# Executive Director's Recommendation

Commission Meeting: December 4, 2014

<b>PROJECT</b> <b>Peace Corps Memorial</b> Washington, DC	<b>NCPC FILE NUMBER</b> 7623
	<b>NCPC MAP FILE NUMBER</b> 00.00(73.10)44040
<b>SUBMITTED BY</b> United States Department of the Interior National Park Service	<b>APPLICANT'S REQUEST</b> Approval of comments on alternative sites
<b>REVIEW AUTHORITY</b> Approval per 40 U.S.C. § 8905	<b>PROPOSED ACTION</b> Approve comments as requested
	<b>ACTION ITEM TYPE</b> Staff Presentation

*Figure 3: Reservation 727 Location*

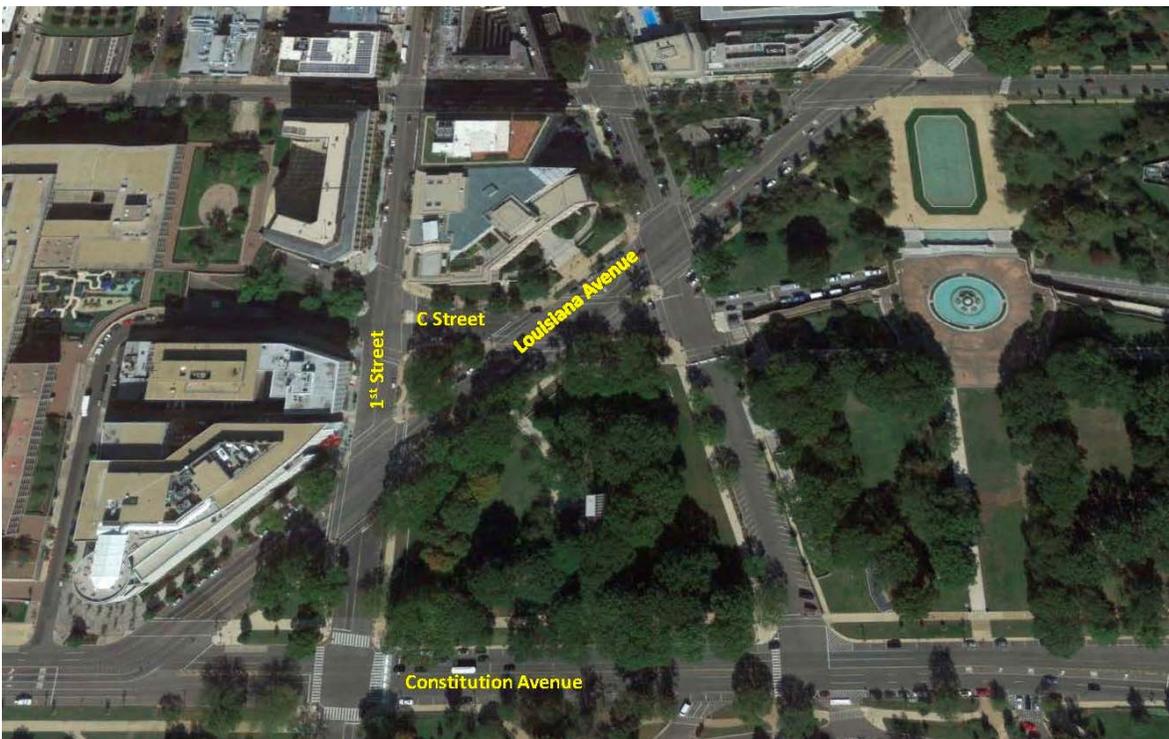
Staff finds that the proposed memorial site is adequate for a modest size memorial and encourages the NPS to continue to evaluate the site for the future Peace Corps Memorial. The site is located about 400 feet north of Constitution Avenue. It is close and convenient to the Monumental Core and its historically significant national monuments, memorials and spaces. In winter months when the trees are leafless, the Commemorative site would be visible from Constitution Avenue. The site is in close proximity to the U.S. Capitol Building and Capitol Grounds, the Peace Monument, other memorials and the Mall.

As noted earlier the site includes multiple large trees, in both the open triangle area and a planting strip along Louisiana Avenue, and staff requests that the NPS evaluate the health of the trees and if determined to be healthy that the memorial design retention the trees. The design and construct of the memorial will need to be done in such a way that is sensitive to the tree roots and requirements of the trees for water.

Given the site's location adjacent to commercial uses, staff sees an opportunity for the site to provide public amenities to be used by office workers, people visiting the Memorial, as well as pedestrians passing by. Currently, the site is void of site furniture and staff recommends that in the design the Memorial provide seating opportunities.

Green space at the site is providing important areas for tree growth and for stormwater management and staff recommends retention of as much green space as possible on the site.

In addition, the Memorial design should include low impact development (LID) stormwater management to meet the federal and local stormwater management standards.

Pursuant to Public Law 104-333 Section 514, the Architect of the Capitol (AOC) transferred jurisdiction of the site in 1996 but retained jurisdiction over the Louisiana Avenue, NW sidewalk. Staff requests that the NPS and PCCF coordinate with the AOC on potential memorial designs and any impact the designs may have on the Louisiana Avenue sidewalk. Staff has discussed the project with the AOC staff, which noted that the AOC has sidewalk design standards that will need to be taken into account if any changes are proposed for the sidewalk and they expressed an interest in maintaining the street trees that are within the planting area. NPS and PCCF should update the AOC regularly on the project.

*Figure 8: Reservation 31 - Looking north*

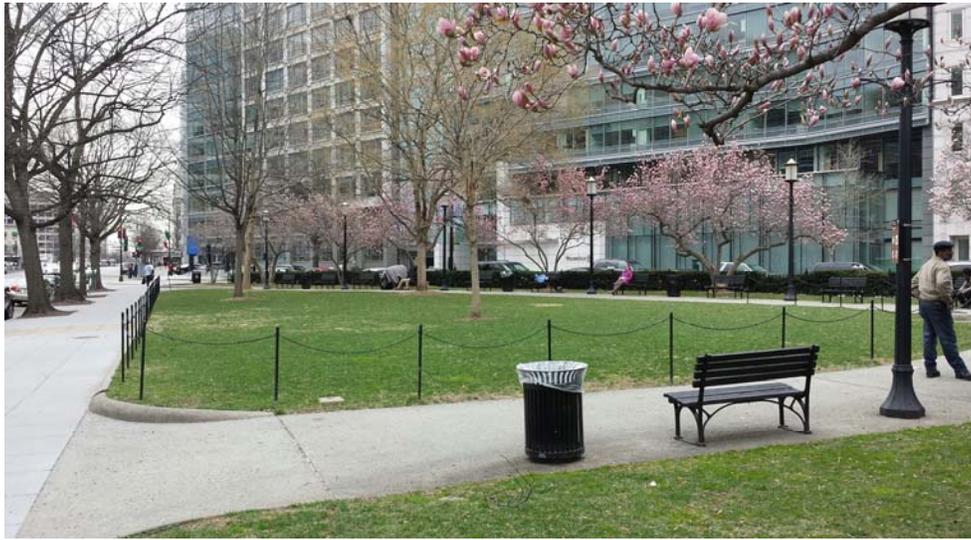
Staff has reviewed the information submitted by the applicant regarding Reservation 31 and has visited the site; the site seems to have strong thematic ties to the Peace Corps and the institutional uses in the Foggy Bottom area of the city. As noted earlier, the site is surrounded by institutional uses that have international ties, such as the Red Cross; the World Bank; the Peace Institute; the State Department and a few embassies north of the site. In addition, the Peace Corps offices are located at L and 20<sup>th</sup> Streets, NW.

The Golden Triangle Business Improvement District (BID) is currently evaluating potential streetscape and public space improvements along Pennsylvania Avenue, NW from 17<sup>th</sup> Street, NW to Washington Circle, and we recommend that the NPS and PCCF work with the Golden Triangle BID on incorporating the memorial into the design.

Given that the site is in an area with limited green space, the site is often used by office workers to eat outside and to sit and relax; the proposed memorial design should also include passive recreation opportunities for the office workers that surround the site, such as benches and trash receptacles.

The site was dedicated to Edward R. Murrow in 1979 by the Secretary of the Interior and includes a plaque in the northeast corner of the site. The site was identified in the 2M Plan, which noted that any memorial that was constructed on the site should include “ancillary interpretive media on the lives of [this] historic [figure].”

Staff would also like to note that the current design of the site dates to the 1930’s and if this site is selected for the memorial the applicant will need to work with the DC SHPO and interested parties to create a design that will be sensitive to the historic fabric.

Figure 11: Rock Creek Park site location

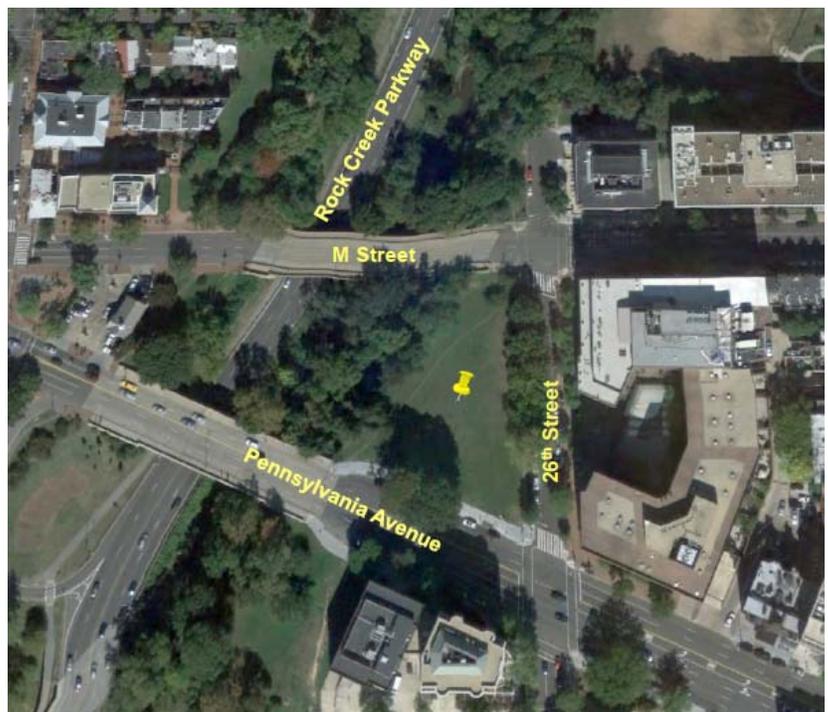
Staff sees some merit for putting the Peace Corps Memorial on a site that is in between two universities and close to students that could be inspired by the memorial to volunteer and serve. However, placing an appropriate commemorative on this large, one-acre site would necessitate building a relatively large-scale work and substantial landscape development. This seems to differ from the intent of the PCCF to build a modest sized memorial and the PCCF has indicated that the site may entail a budget and construction scope requiring much more funding than the PCCF's projected budget anticipates and beyond its fundraising capability. Staff recommends that the Commission discourage the applicant from continuing to peruse the site for the Peace Corps Memorial.
